Permit # 902034 City of Portland BUILDING PERMIT APPLICATION Fee \$25. Zone _____ Map # _____ Lot# _____

STANDARD BOUNDARY SURVEY
 AND
 95-97 TOPOGRAPHIC SITE PLAN
 PROPERTY AT
 89-97 AVALON ROAD
 PORTLAND, MAINE CUMBERLAND COUNTY
 FOR
 ANDREW & JULIE DeRICE
 2 FLINTLOCK LANE
 FAIRBANKS, ME 04740

RE: 95-97 Avalon Road, Portland

STANDARD BOUNDARY SURVEY
 AND
 TOPOGRAPHIC SITE PLAN
 PROPERTY AT
 89-97 AVALON ROAD
 PORTLAND, MAINE CUMBERLAND COUNTY

SUBDIVISION PLAT

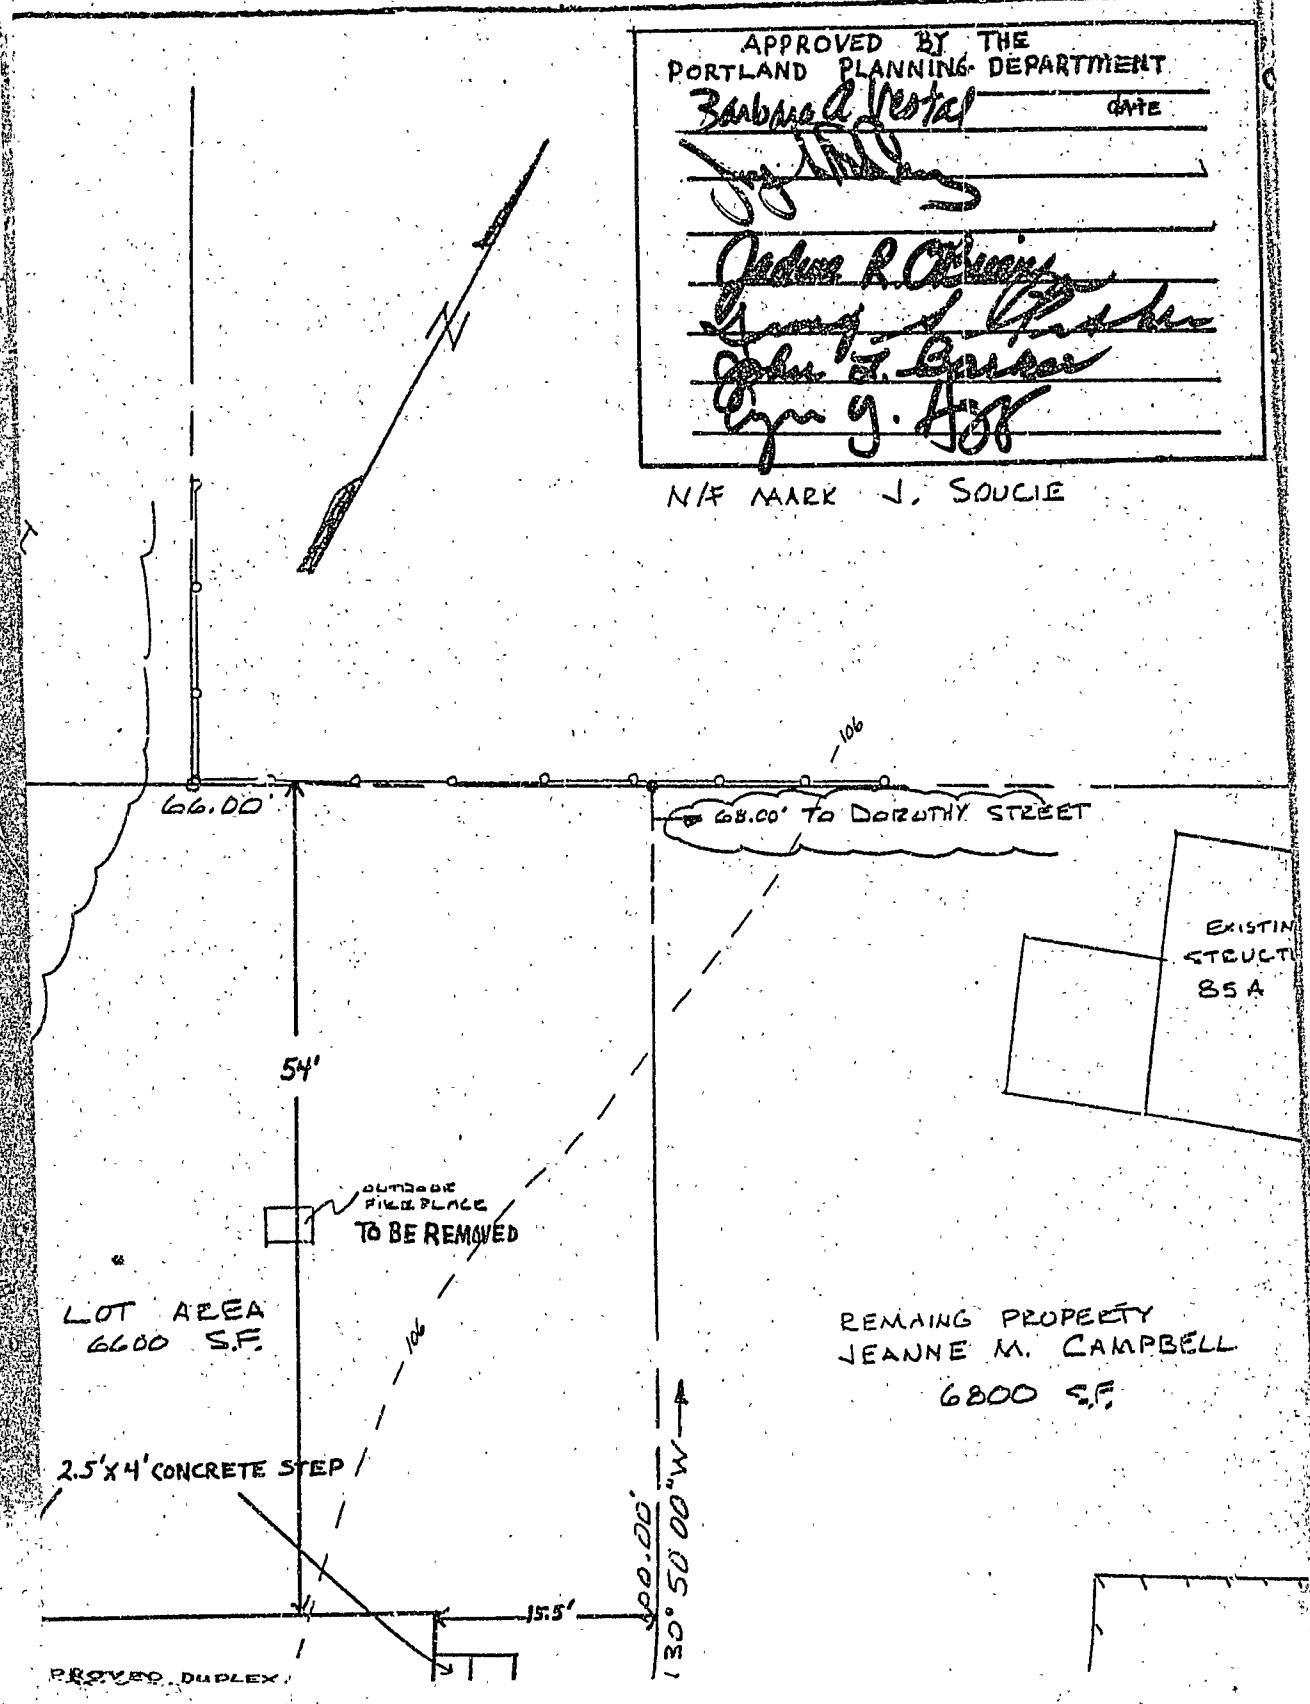
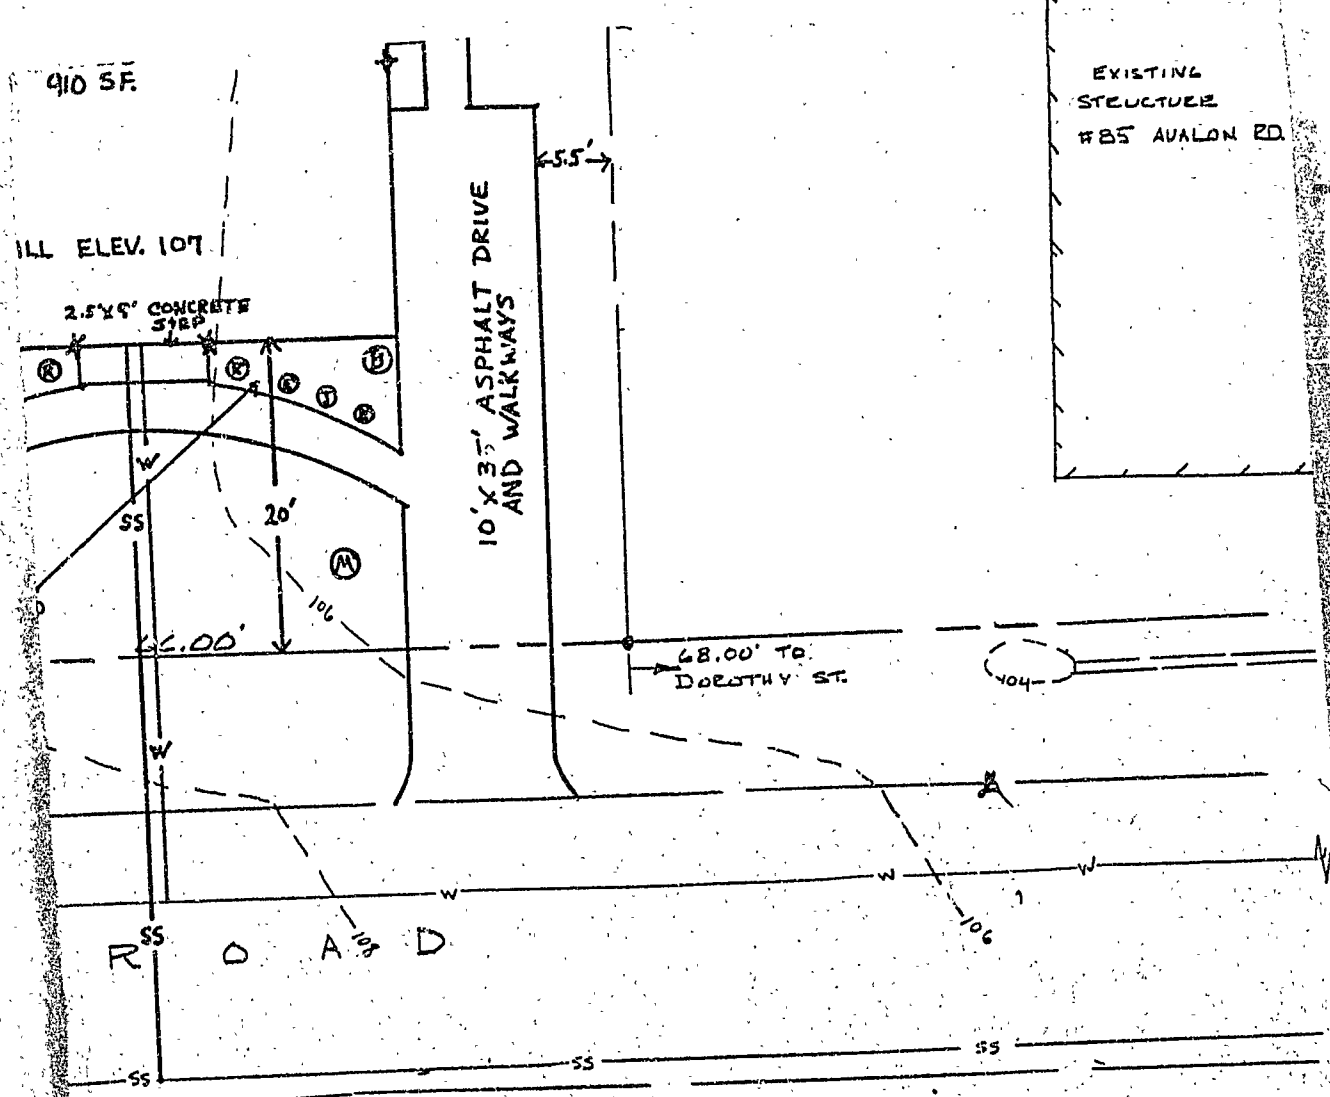
REASONS: *Note #5 on plans does not indicate actual travel distance as measured along the normal path of travel of fire Dept. Apparatus must be within 800' in this case.*
 (Attach Separate Sheet if Necessary)

REASONS: *Height not shown. Height must be within 800' measured along the normal path of travel of fire apparatus.*

- 4) ELEVATIONS REFER TO NAIL LOCATED IN UTILITY POLE NUMBER 7 AT THE INTERSECTION OF AVALON ROAD AND RANGE STREET. ELEVATION 103.68 CITY DATUM AS PER PLANS FOR SEWER EXTENSION ON AVALON ROAD.
- 5) FIRE HYDRANT LOCATED ON THE NORTHEASTERLY SIDE OF DOROTHY STREET, 155 FEET SOUTHWESTERLY OF THE INTERSECTION WITH AVALON ROAD AND 120 FEET NORTHERLY OF NORTHERLY CORNER OF THE SUBJECT PROPERTY.
